Standards Update Transmittal

Reference Number: **2021-04**

Standards: **Standard Drawings, AR-2.0, AR-3.0, AR-4.3, AR-4.5, AR-4.7, AR-4.8, D-2, G-1, SD-16, ST-20, ST-21B, ST-32, T-6A, T-9A**

DRAWING NUMBER
AR - 2.0

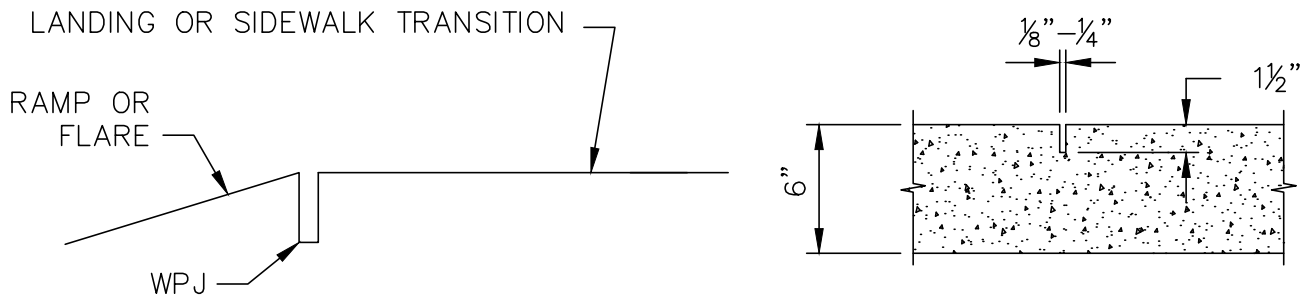
- a. AR-2.0 CURB RAMP ELEMENTS DEFINITIONS AND STANDARDS: add “or below” to note 2a; change “face of curb” to “flowline” in note 6b and 8b
- b. AR-3.0 CURB RAMP GENERAL DETAILS: change concrete section to 6” from 5.5”; change AB section to 6” from 4”

DRAWING NUMBER
AR - 4.3

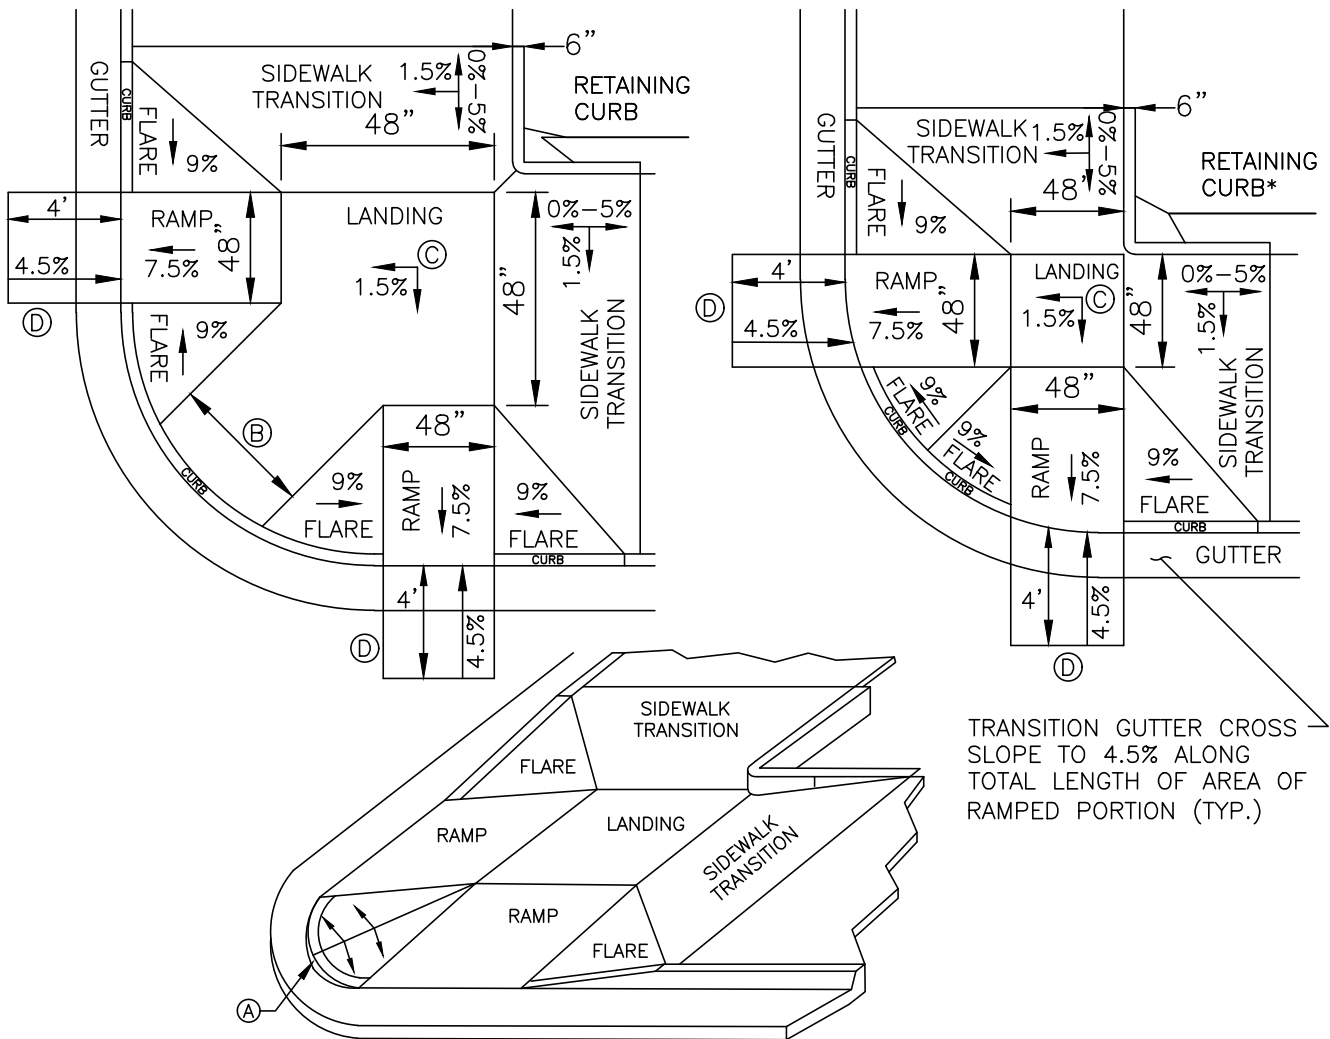
- c. AR-4.3 DUAL PERPENDICULAR CURB RAMPS WITH ATTACHED SIDEWALK: change “face of curb” to “flowline” in note D.
- d. AR-4.5 DUAL FLARED PERPENDICULAR CURB RAMPS WITH DETACHED SIDEWALK: change “face of curb” to “flowline” in note D.

DRAWING NUMBER
AR - 4.8

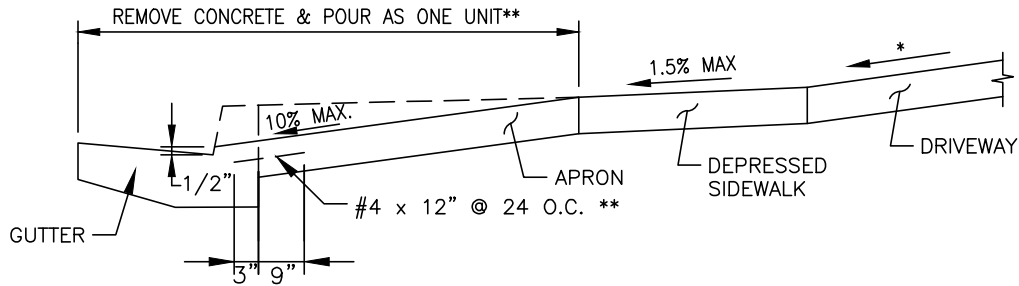
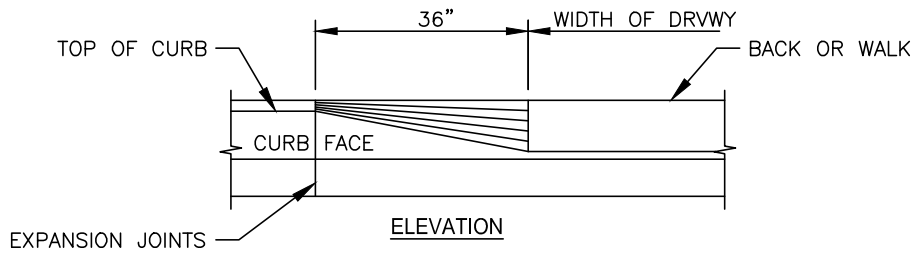
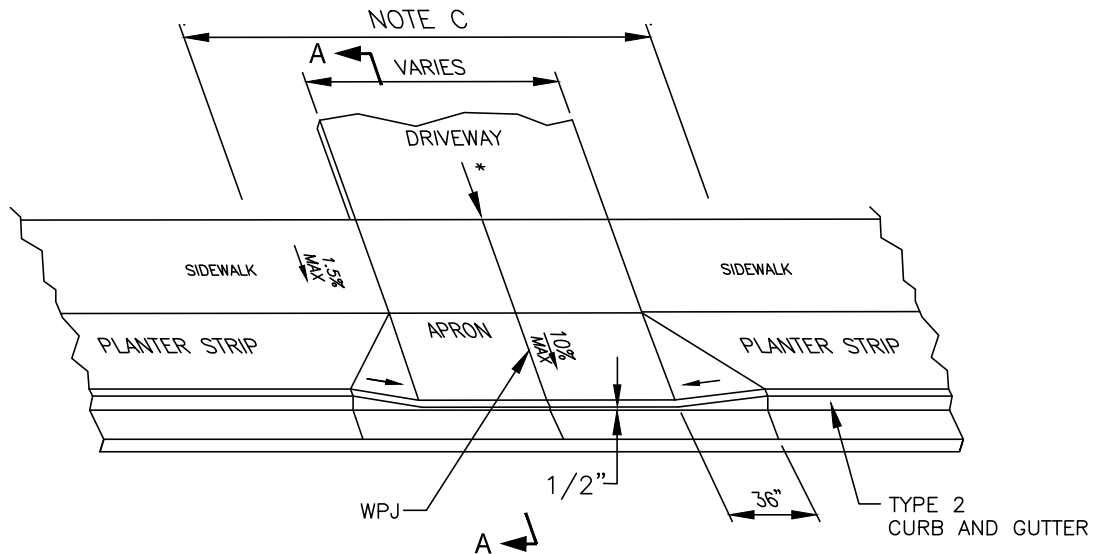
- e. AR-4.7 SIDEWALK DRIVEWAY DETAIL: change note * to read “See section 4-7 of the improvement standards.”; move section A-A cut line to plan view.
- f. AR-4.8 DETACHED SIDEWALK DRIVEWAY DETAIL: change note * to read “See section 4-7 of the improvement standards.”; move section A-A cut line to plan view.

DRAWING NUMBER
D - 2

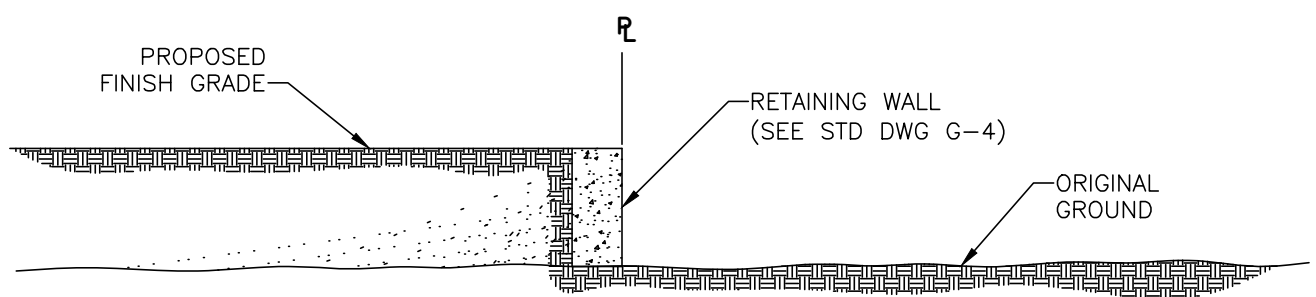
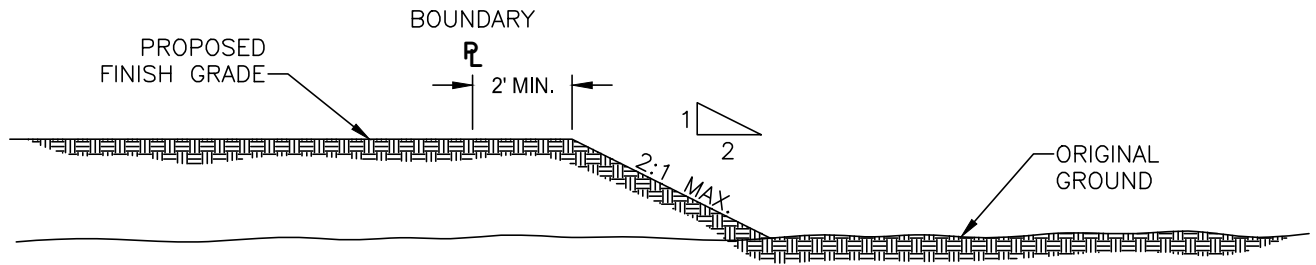
- g. D-2 DRAFTING STANDARDS: change existing line style to differentiate between the proposed condition and existing condition.
- h. G-1 EXTERIOR PERIMETER PROPERTY LINE GRADING: move property line leader to the correct line.

DRAWING NUMBER
SD - 16

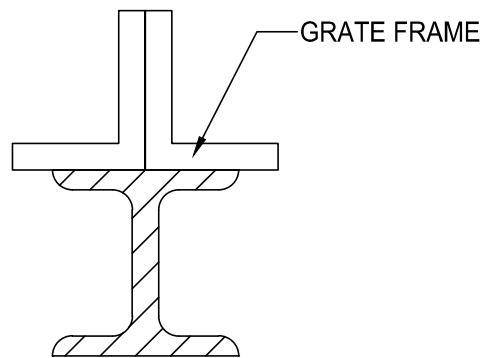
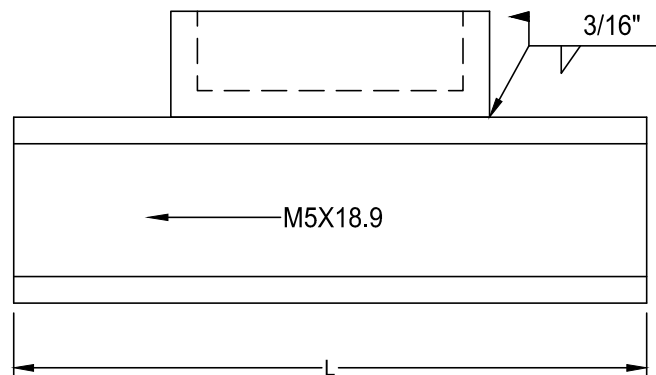
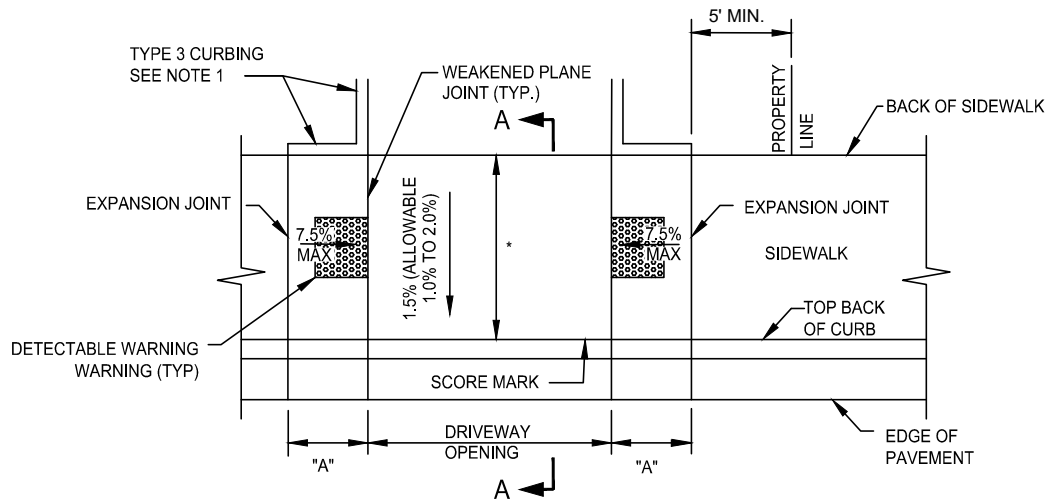
- i. SD-16 CENTER SUPPORT ASSEMBLY FOR MULTIPLE GRATES: add “Greenbook” to read “(APWA Greenbook Standard Plan 301)” in note 2.
- j. ST-20 COMMERCIAL DRIVEWAYS TYPE A-6: move section A-A cut line to plan view; add “sidewalk” label on plan view.

DRAWING NUMBER
ST - 21B

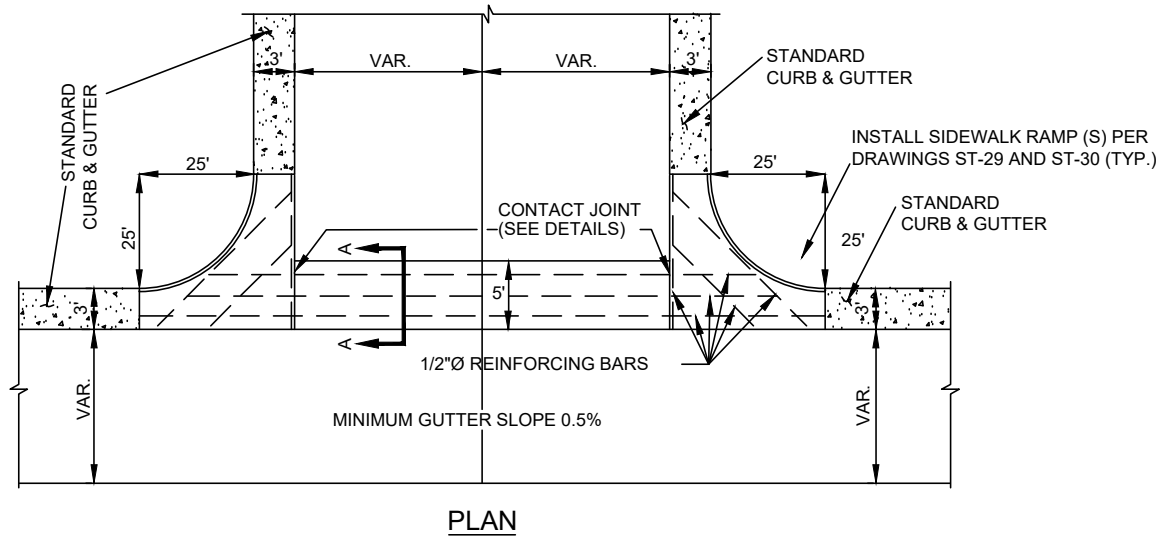
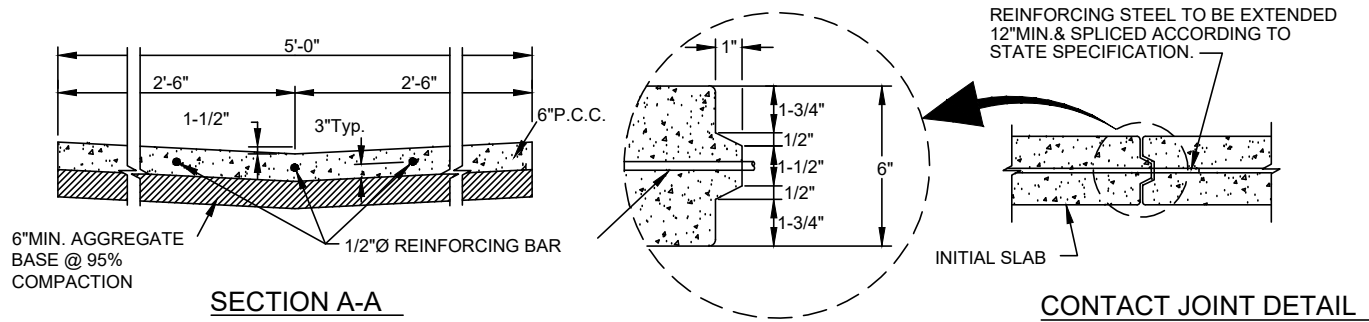
- k. ST-21B SIDEWALK RAMP FOR A-7 DRIVEWAYS WITHOUT ADDITIONAL R/W: change AB section to 6” from 4”.
- l. ST-32 CROSS GUTTER: revise to 95% compaction from 90% to match with other drawings.

T - 6A

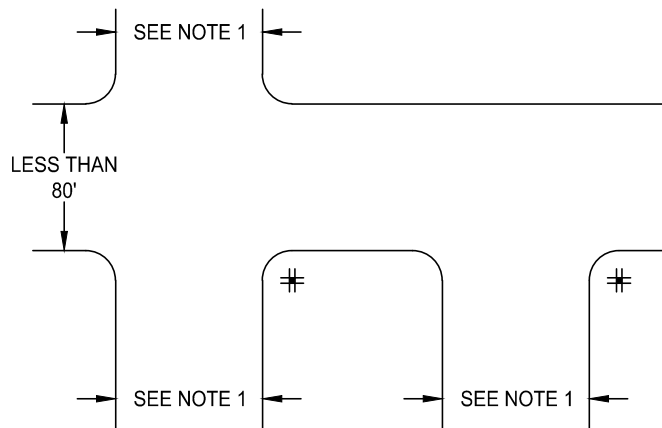
- m. T-6A STREET NAME SIGN GENERAL LOCATION: change T-5 to T-5A and T-5B
- n. T-9A TYPICAL STREET CROSS SECTIONS, change (66’) to (68’), typo.
